Access Compliance Report

Public Rights-of-Way

Intersection ID: 12186	Main Street: E_11TH_ST	Cross Street: E_BROOKSHIRE_FR_RA	Location: W
ADA ID: 5D838DDFE9CA	Ramp Type: PerpDiag	Initial Pass/Fail: Fail	Overall Compliance: No
		Severity Score: 12.5

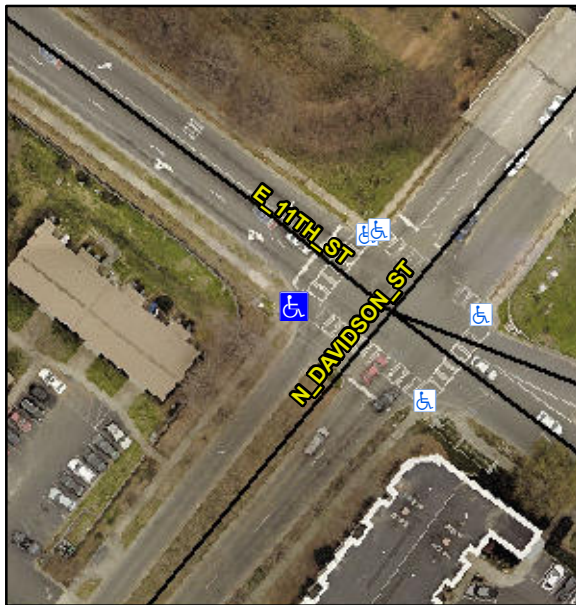
Not Found, R304.2.2

Compliance	Description	Data	Compliance	Description	Data
N/A	Ramp Length (in)	60.0	No	Ramp Slope (%)	8.4
Yes	Ramp Width (in)	48.0	Yes	Ramp XSlope (%)	1.2
N/A	Flare Type LT	N/A	N/A	Flare Type RT	N/A
N/A	Flare Slope LT (%)	N/A	N/A	Flare Slope RT (%)	N/A
N/A	Flare Traversable LT?	N/A	N/A	Flare Traversable RT?	N/A
N/A	Landing Length (in)	N/A	N/A	DWS Provided?	N/A
N/A	Landing Width (in)	N/A	N/A	DWS Contrast?	N/A
N/A	Landing Slope (%)	N/A	N/A	DWS Length (in)	N/A
N/A	Landing X Slope (%)	N/A	N/A	DWS Full Width?	N/A
N/A	Landing Curb? (Y/N)	N/A	N/A	DWS Offset (in)	N/A
N/A	Shared Landing?	N/A			
N/A	Gutter Ponding?	N/A	N/A	Gutter Slope (%)	N/A
N/A	Gutter Lip Ht (in)	N/A	N/A	Gutter X Slope (%)	N/A
N/A	Painted X Walk1?	Yes	N/A	Painted X Walk2?	Yes
	X Walk 1 Direction	To SE		X Walk 2 Direction	To NE
N/A	X Walk 1 Width (in)	120.0	N/A	X Walk 2 Width (in)	120.0
	X Walk 1 Slope (%)	0.0		X Walk 2 Slope (%)	3.2
	X Walk 1 X Slope (%)	1.5		X Walk 2 X Slope (%)	1.9

Remove & Replace Curb Ramp With Two New Directional Ramps or Equivalent.
